Access Compliance Report

Public Rights-of-Way

Intersection ID: 28409	Main Street: LAUREL_RUN_DR	Cross Street: LAUREL_RUN_DR	Location:	N
ADA ID: 4B7F11D02B13	Ramp Type: PerpDiag	Initial Pass/Fail: Fail	Overall Compliance: No	Severity Score: 12.5

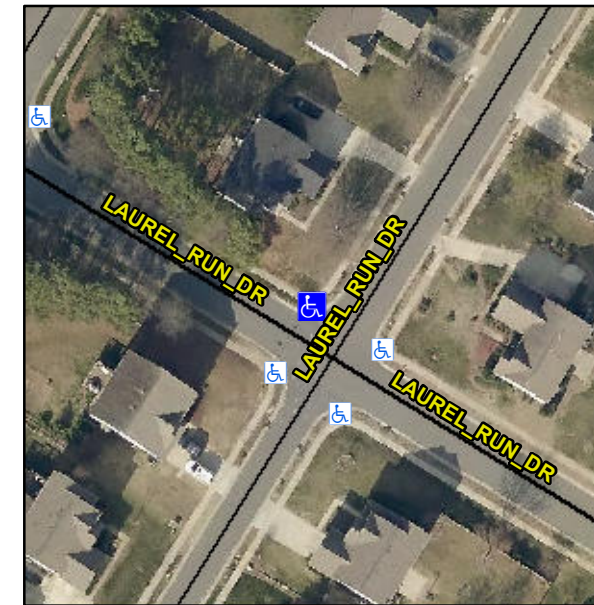
Compliance	Description	Data	Compliance	Description	Data
N/A	Ramp Length (in)	48.0	Yes	Ramp Slope (%)	5.8
Yes	Ramp Width (in)	84.0	No	Ramp XSlope (%)	6.6
N/A	Flare Type LT	N/A	N/A	Flare Type RT	N/A
N/A	Flare Slope LT (%)	N/A	N/A	Flare Slope RT (%)	N/A
N/A	Flare Traversable LT?	N/A	N/A	Flare Traversable RT?	N/A
N/A	Landing Length (in)	N/A	N/A	DWS Provided?	N/A
N/A	Landing Width (in)	N/A	N/A	DWS Contrast?	N/A
N/A	Landing Slope (%)	N/A	N/A	DWS Length (in)	N/A
N/A	Landing X Slope (%)	N/A	N/A	DWS Full Width?	N/A
N/A	Landing Curb? (Y/N)	N/A	N/A	DWS Offset (in)	N/A
N/A	Shared Landing?	N/A			
N/A	Gutter Ponding?	N/A	N/A	Gutter Slope (%)	N/A
N/A	Gutter Lip Ht (in)	N/A	N/A	Gutter X Slope (%)	N/A
N/A	Painted X Walk1?	No	N/A	Painted X Walk2?	No
	X Walk 1 Direction	To SW		X Walk 2 Direction	To SE
N/A	X Walk 1 Width (in)	N/A	N/A	X Walk 2 Width (in)	N/A
	X Walk 1 Slope (%)	8.5		X Walk 2 Slope (%)	8.9
	X Walk 1 X Slope (%)	6.0		X Walk 2 X Slope (%)	4.5

Remove & Replace Curb Ramp With Two New Directional Ramps or Equivalent.
